Addendum No. 6

PROJECT NO. 161026-00

PROJECT TITLE: Renovate Plant Science Building - Phase 2

DATE: **November 19, 2026**

1 S2.9 SECTION
1/4" = 1'-0"

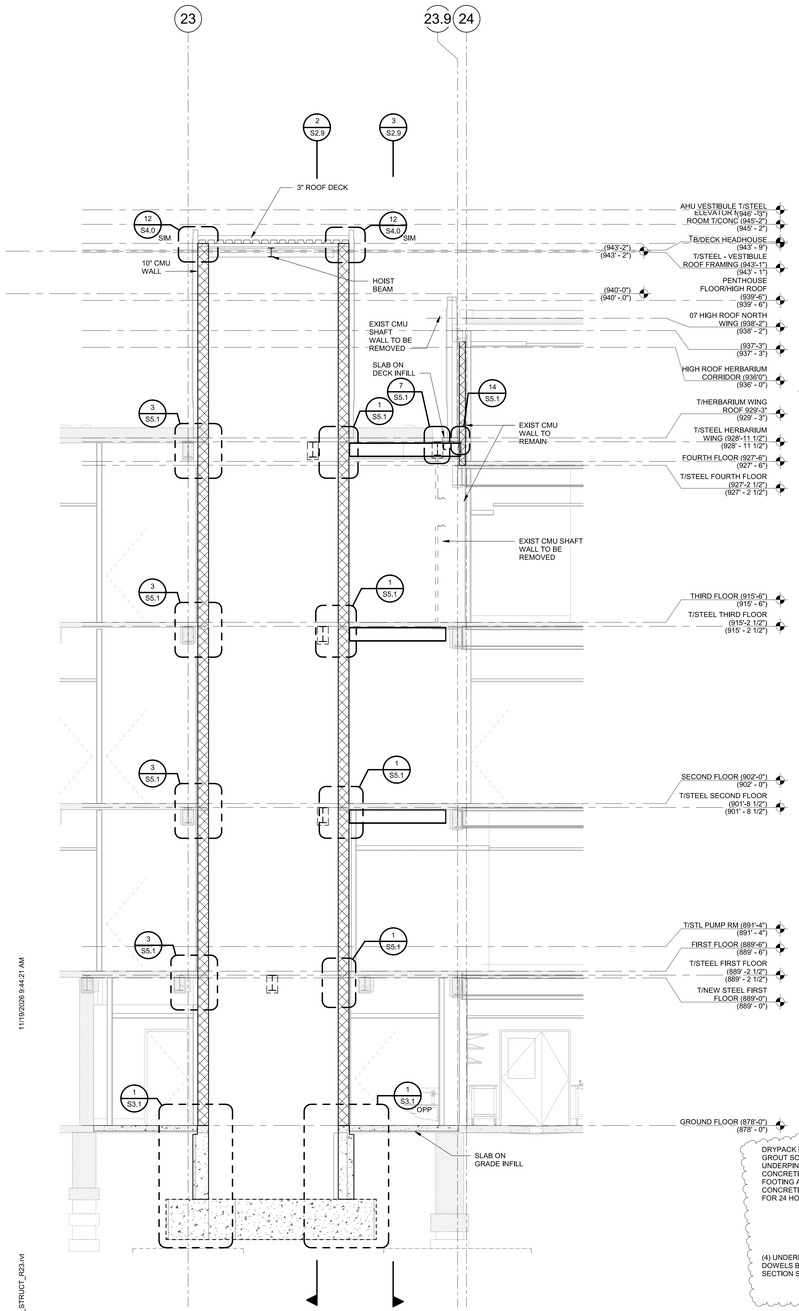
6.2j: S2.3 – REVISED detail 1 with additional information for the foundation region surrounding the new elevator shaft.
6.2k: S2.9 – REVISED detail 2 with additional information for the foundation region surrounding the new elevator shaft.

2 NORTH WING EAST DEMOLITION ELEVATION- PHASE 2

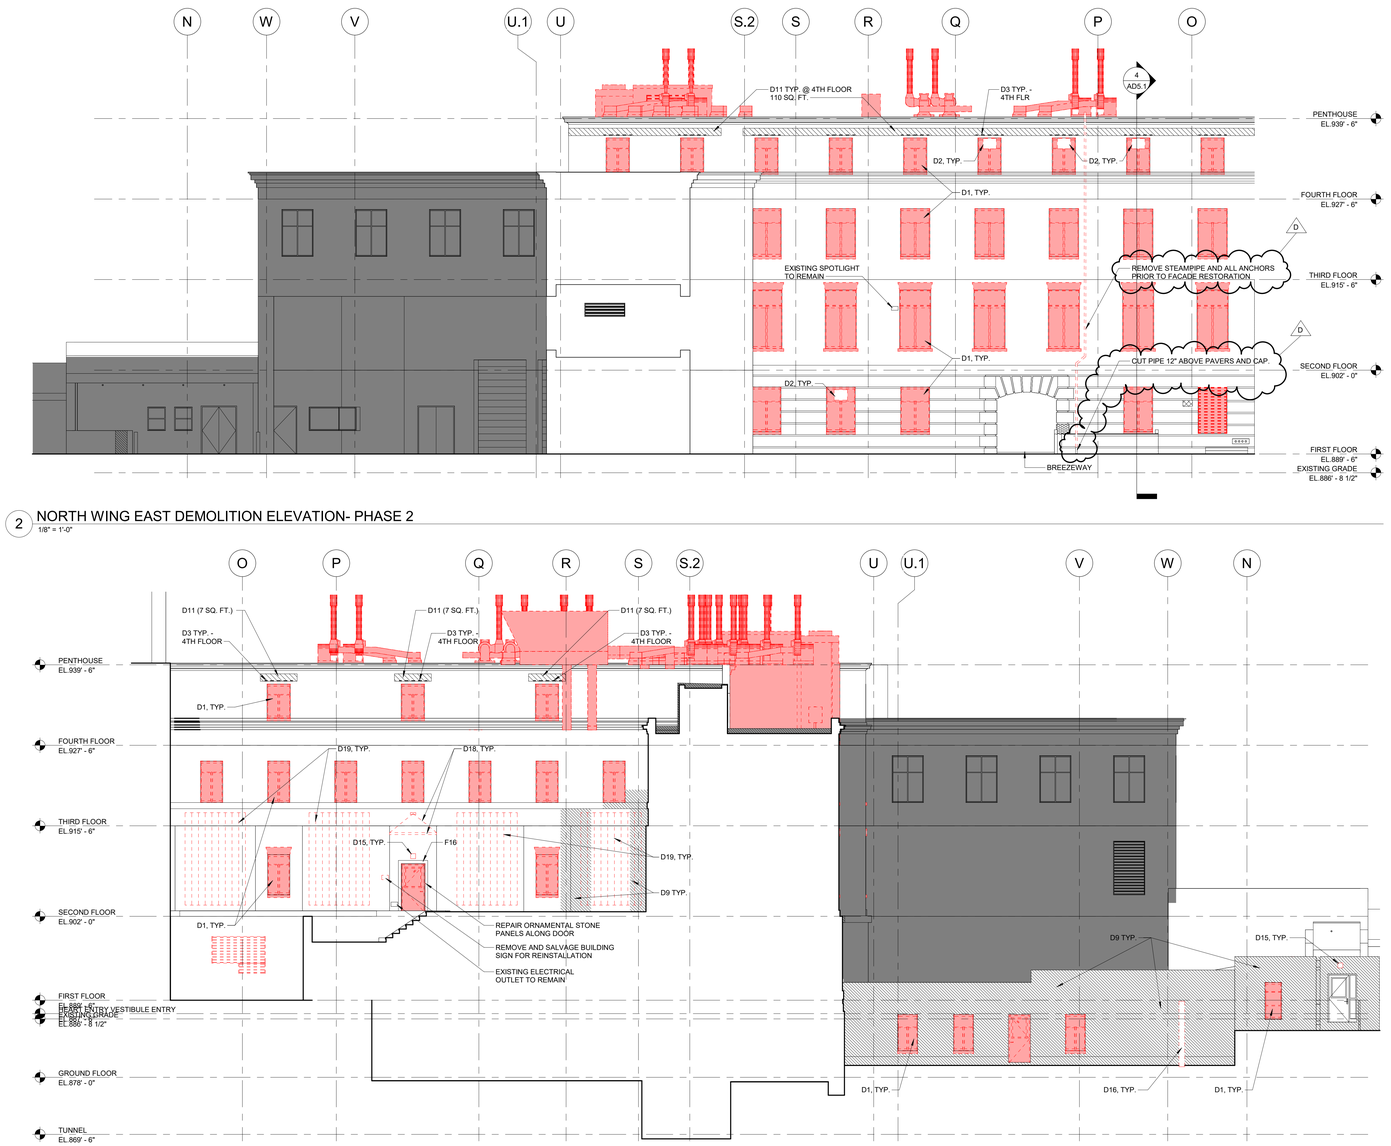
6.2n1: AD3.4 – On view 2, North Wing East Demolition Elevation – Phase 2: REVISE steam pipe removal to show 12" of pipe remaining at the base (to be capped). DELETE note that read, "STEAMPIPE TO BE CAPPED AND REMOVED" and REPLACE with: "REMOVE STEAMPIPE AND ALL ANCHORS PRIOR TO FACADE RESTORATION". DELETE note that read, "PATCH PAVERS AND WATERPROOFING AT PIPE REMOVAL. INFILL CONCRETE DECK." and REPLACE with: "CUT PIPE 12" ABOVE PAVERS AND CAP".

PLUMBING RISER DIAGRAM - SANITARY WASTE/VENT (PHASE 2)
NTS

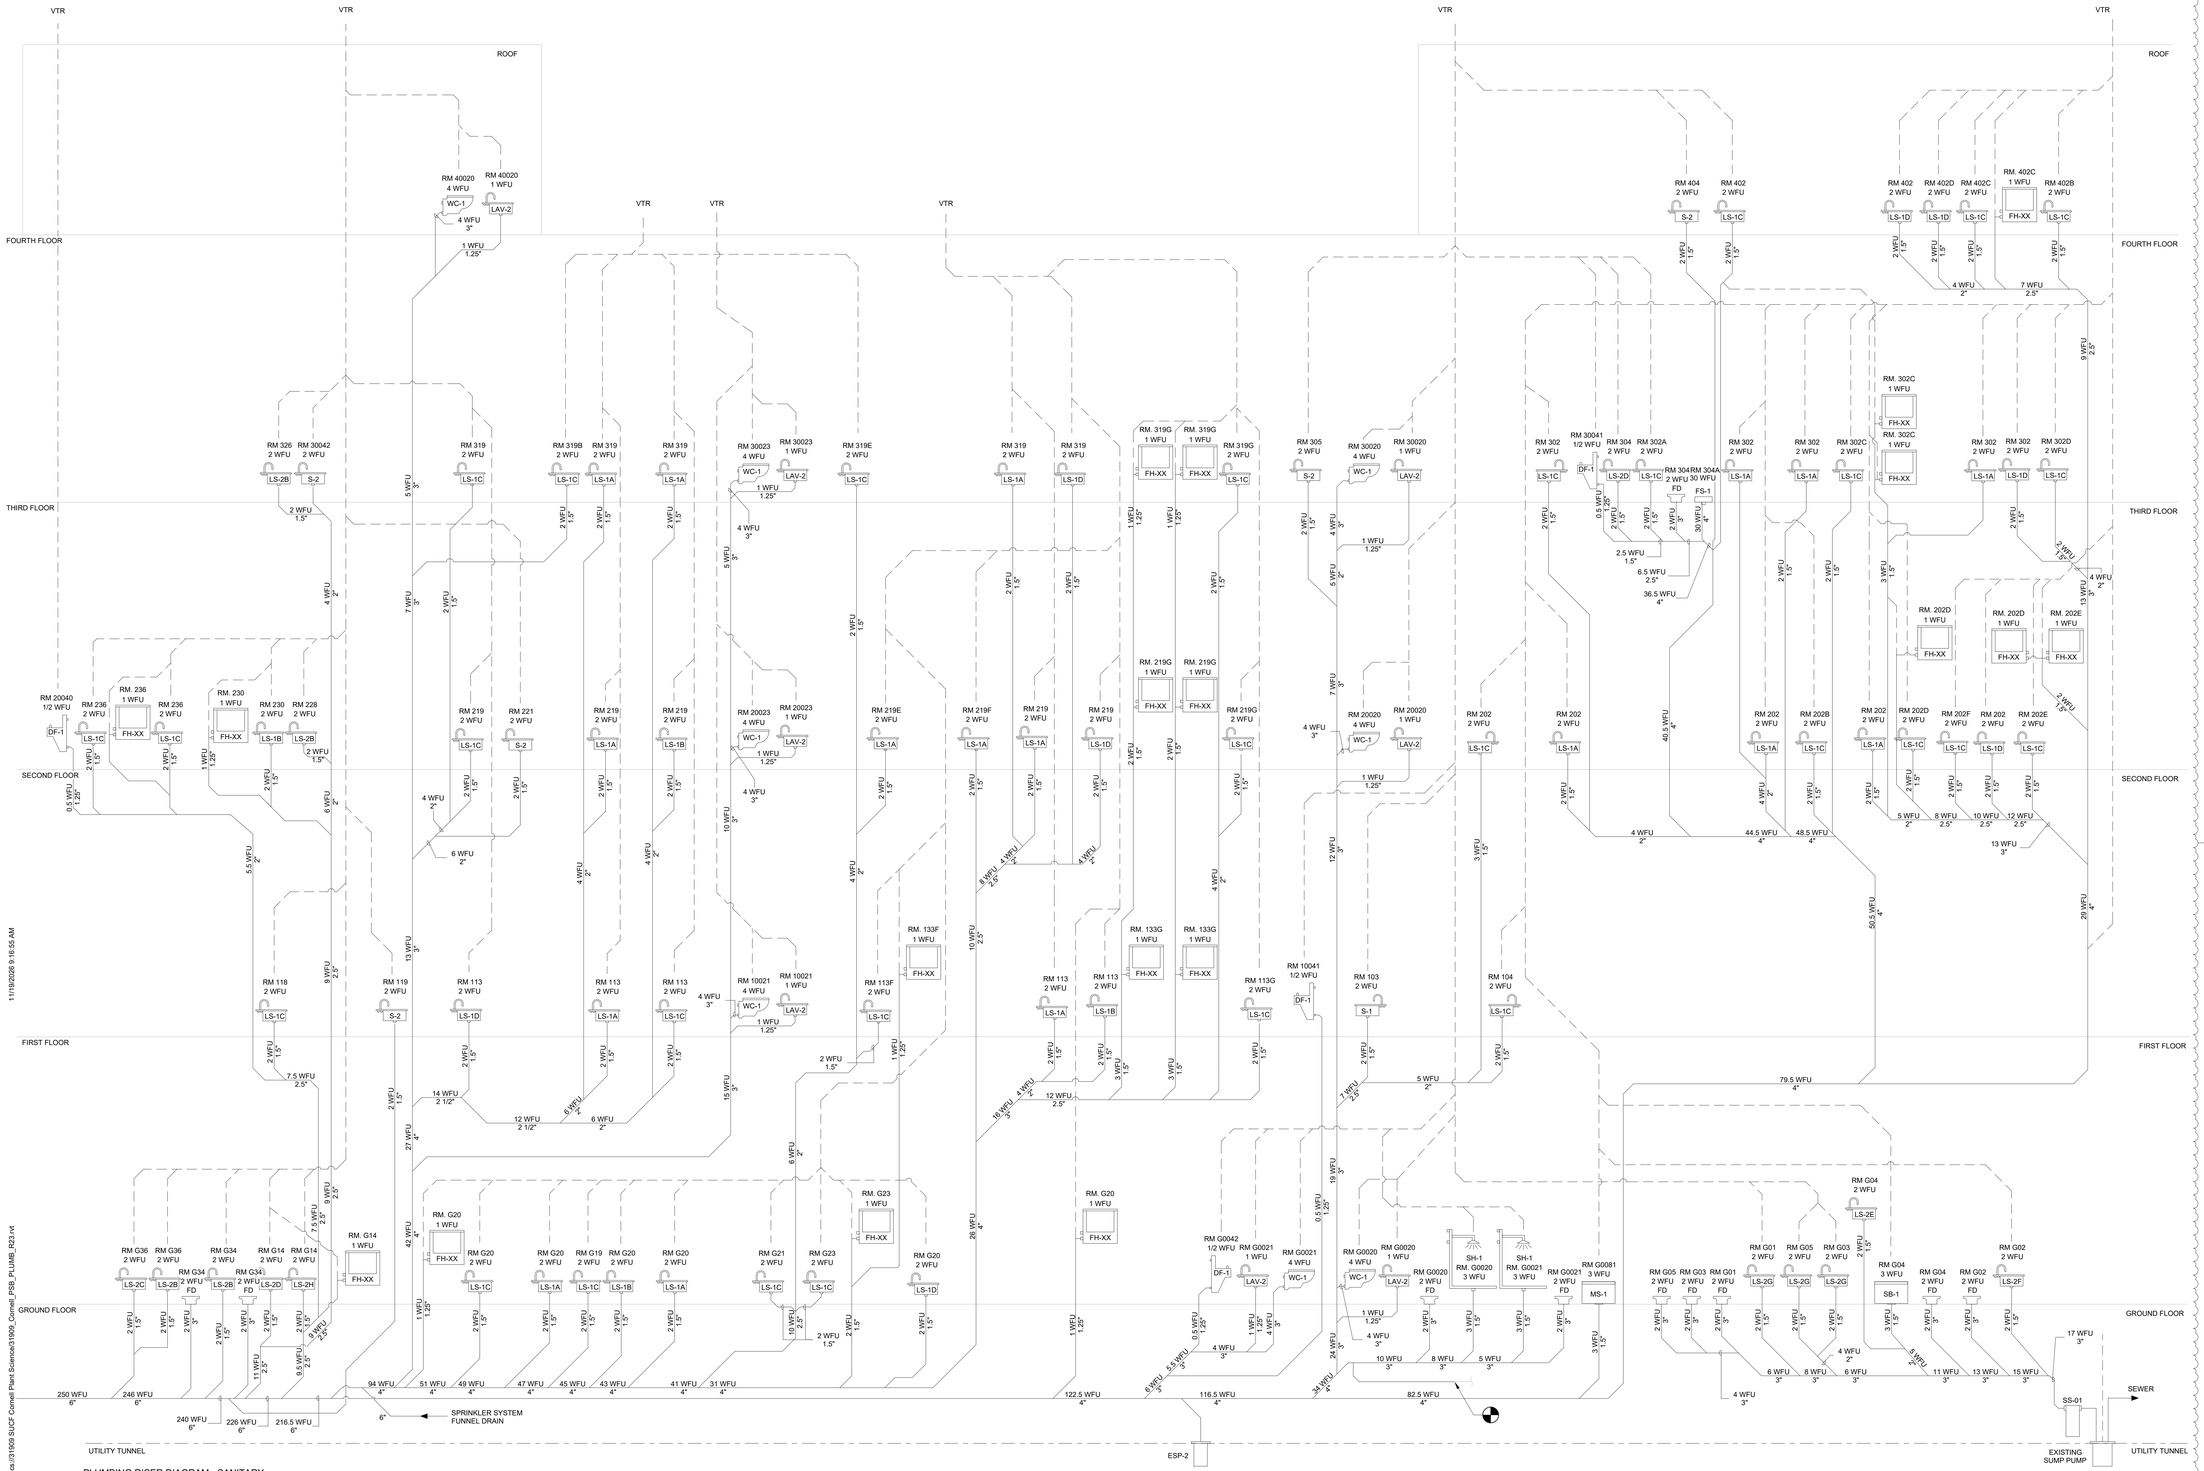
6.2au: P7.3 – REVISED Plumbing Waste and Vent Schematic Riser Diagram (Phase 2). REPLACE sheet in its entirety with the attached version.

1 PLUMBING RISER DIAGRAM - CONDENSATE DRAINAGE (PHASE 2)
NTS

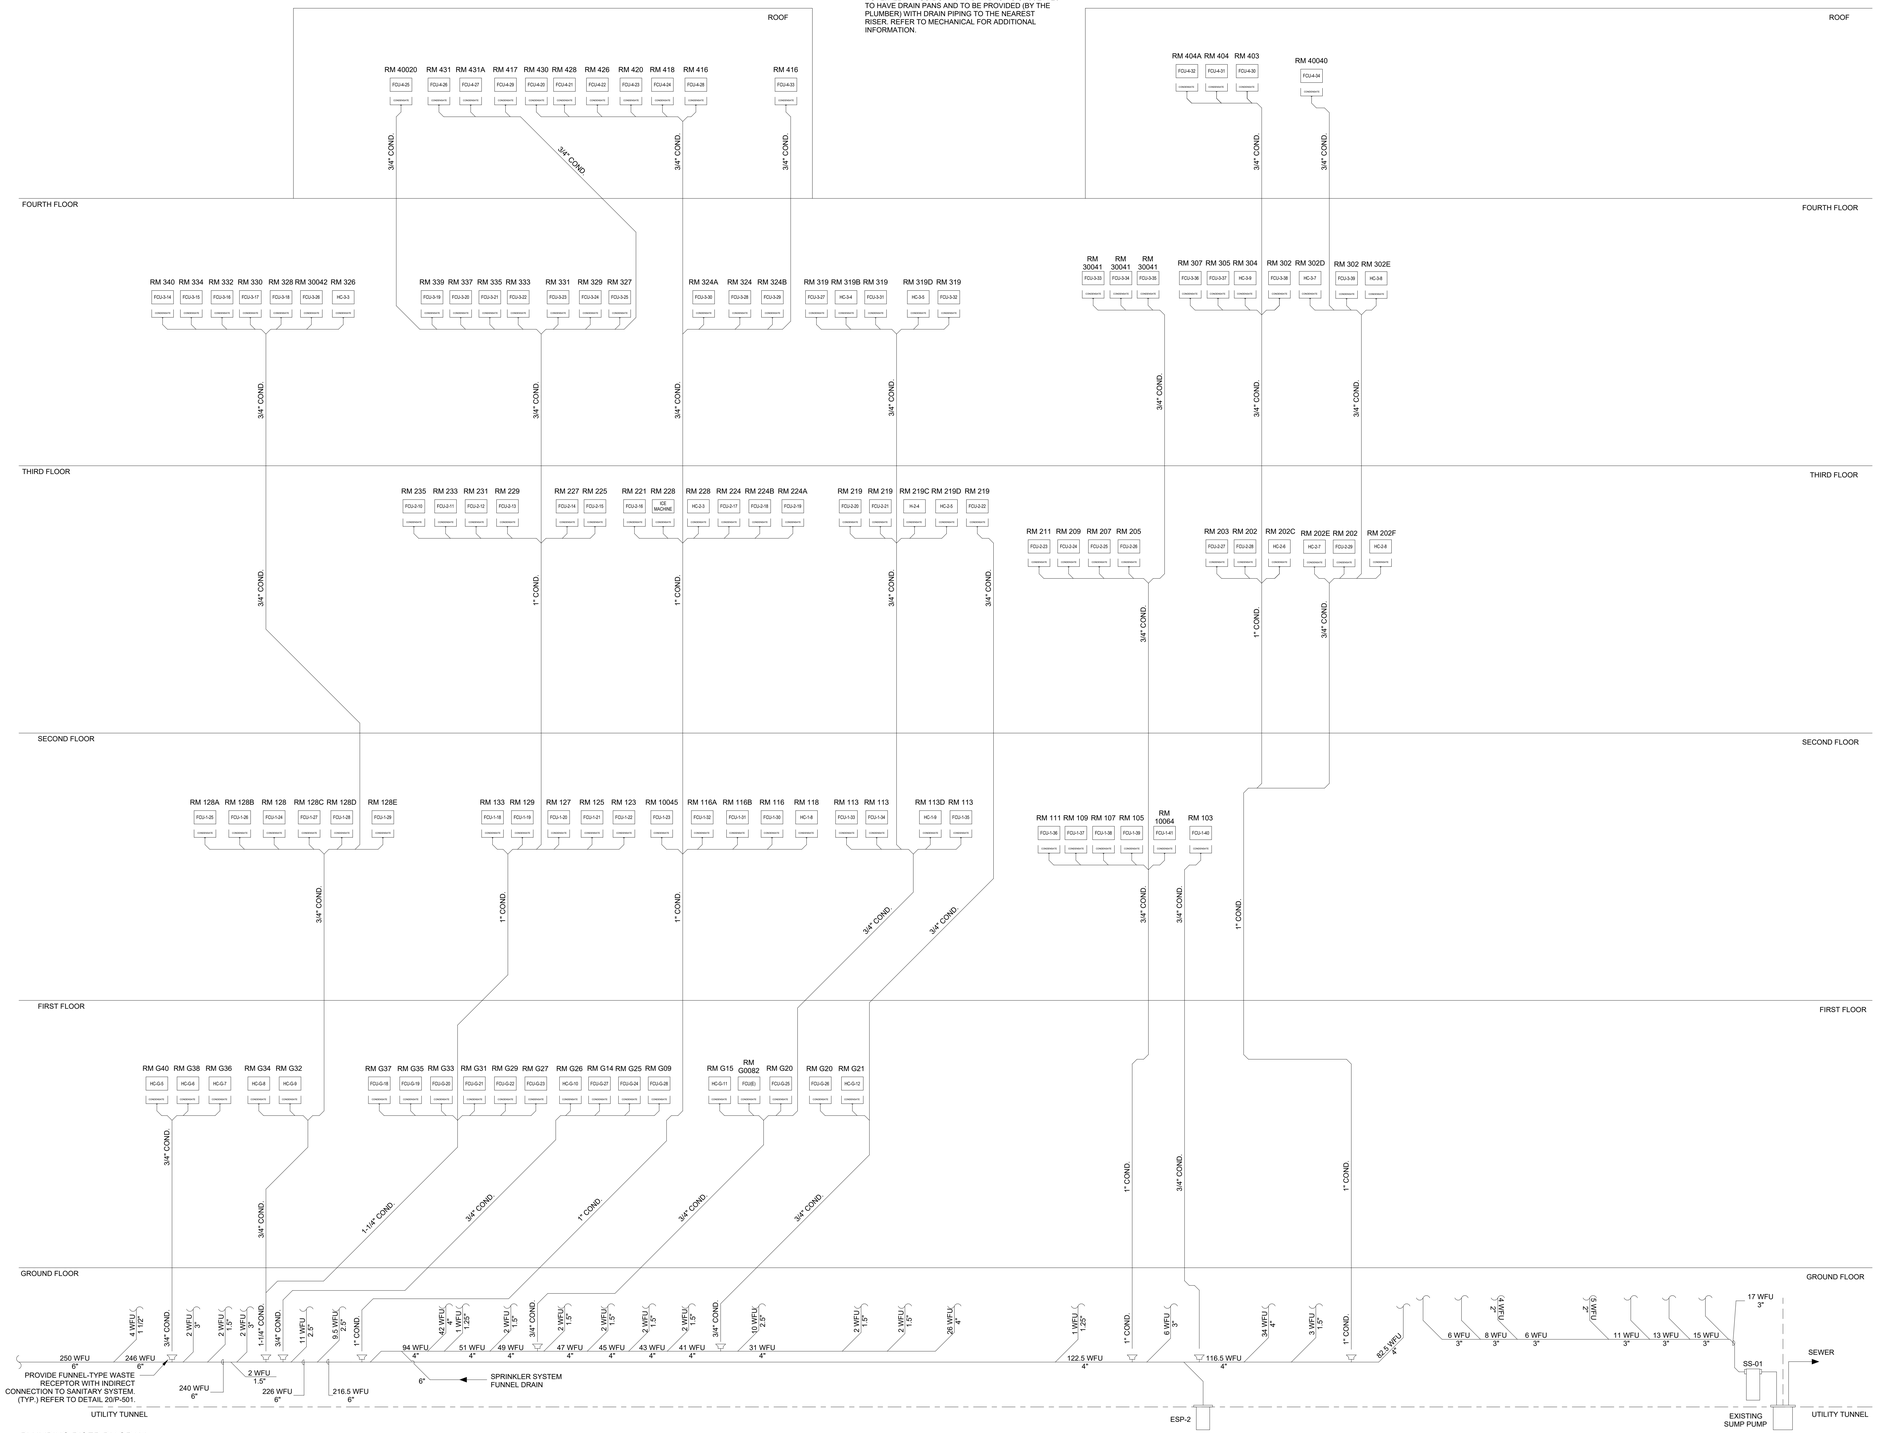
6.2av: P7.4 – REVISED Plumbing Condensate Drainage Schematic Riser Diagram (Phase 2)
